#### **SUNDRY NOTICES AND REPORTS ON WELLS** Do not use this form for proposals to drill or to re-enter an abandoned well. Use form 3160-3 (APD) for such proposals.

#### Buena Suerte 29M # 1T

#### **Plug and Abandonment Procedure**

#### BLM FLUID MINERALS Geologic Report

### DJR Operating, LLC Proposed Wellbore Diagram

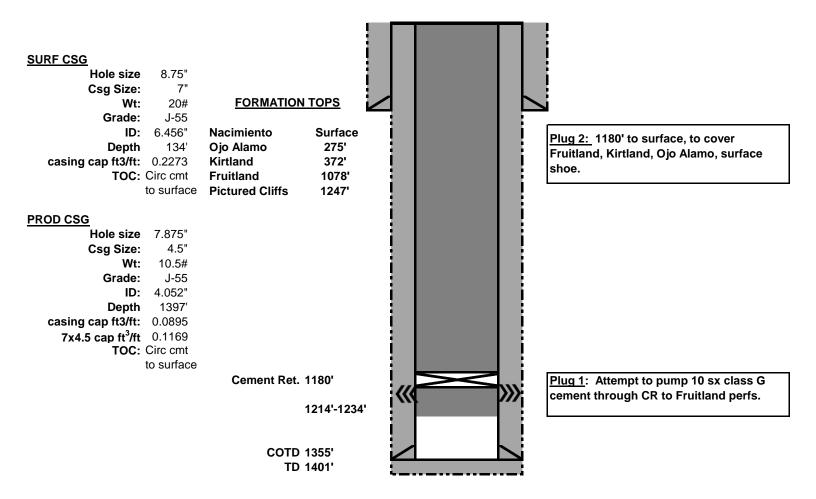
- The proposed plugging plan, if executed as presented, will adequately protect the freshwater sands in this well bore.
- Please ensure that the tops of the Pictured Cliffs and Fruitland formations as well as the entire Ojo Alamo aquifer, identified in this report, are isolated by proper placement of cement plugs. This will protect the freshwater sands in this well bore.
